DEVELOPMENT NO.:	24020254
APPLICANT:	Ormond Nominees Pty Ltd
AGENDA ITEM NO:	3.1
ADDRESS:	75-76 South Terrace, Adelaide
NATURE OF DEVELOPMENT:	Construction of an 11 level residential flat building
ZONING INFORMATION:	<p>Zones:</p> <ul style="list-style-type: none"> • Capital City <p>Sub Zones:</p> <ul style="list-style-type: none"> • City Frame <p>Overlays:</p> <ul style="list-style-type: none"> • Airport Building Heights (Regulated) (All structures over 70 metres AHD) • Affordable Housing • Building Near Airfields • Design • Hazards (Flooding - Evidence Required) • Noise and Air Emissions • Prescribed Wells Area • Regulated and Significant Tree <p>Technical Numeric Variations (TNVs):</p> <ul style="list-style-type: none"> • Maximum Building Height (Metres) (Maximum building height is 36m)
LODGEMENT DATE:	15 July 2024
RELEVANT AUTHORITY:	City of Adelaide Council Assessment Panel
PLANNING & DESIGN CODE VERSION:	Version 2024.12 – Consolidated 4 July 2024

CATEGORY OF DEVELOPMENT:	Code Assessed – Performance Assessed
NOTIFICATION:	Yes
RECOMMENDING OFFICER:	SB
REFERRALS STATUTORY:	The Secretary of the relevant Commonwealth Department responsible for administering the Airports Act 1996

Figure 9.5.2 – Distance between Proposed Development and Nearest Residential Land Use in a Neighbourhood-Type Zone

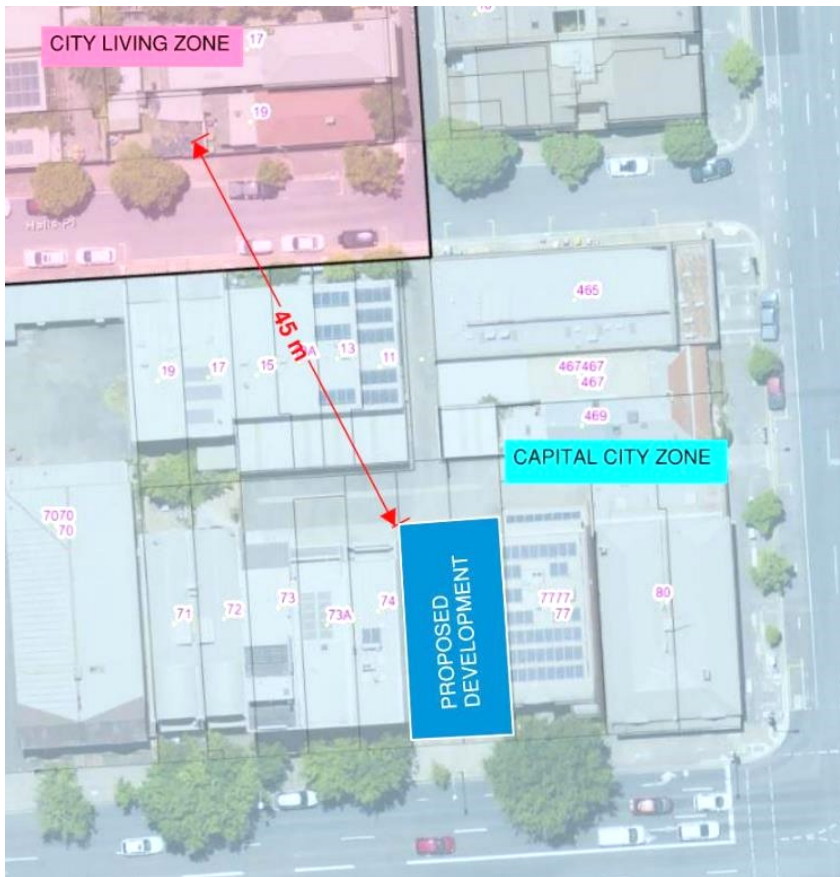
Figure 9.5.2 demonstrates the nearest residential land use in a neighbourhood-type zone is 19 Collins Street which is a dwelling in the City Living Zone. The distance between the rear of the proposal to the private open space of 19 Collins Street will be approximately 45 metres. This is a distance more than three times what could be considered within the scope of direct overlooking.

Balconies fronting South Terrace comprise screening to both sides, allowing views only southward toward the Park Lands. It is not possible to directly overlook the habitable room windows or private open spaces of adjacent residential uses in neighbourhood-type zones.

Figure 9.5.2 demonstrates all adjoining properties within 15 metres of the site are in the Capital City Zone, where there is no policy requiring direct overlooking to be mitigated as this zone is not a 'neighbourhood-type zone'. Nonetheless, the rear balconies on levels 1, 2 and 3 will comprise obscure glazing, with views from level 4 upwards likely to be over the top of adjacent dwellings to the north and toward the northern horizon.

The development therefore mitigates direct overlooking of habitable rooms and private open spaces of adjacent residential uses in neighbourhood-type zones. Design in Urban Areas PO 16.1 is achieved.
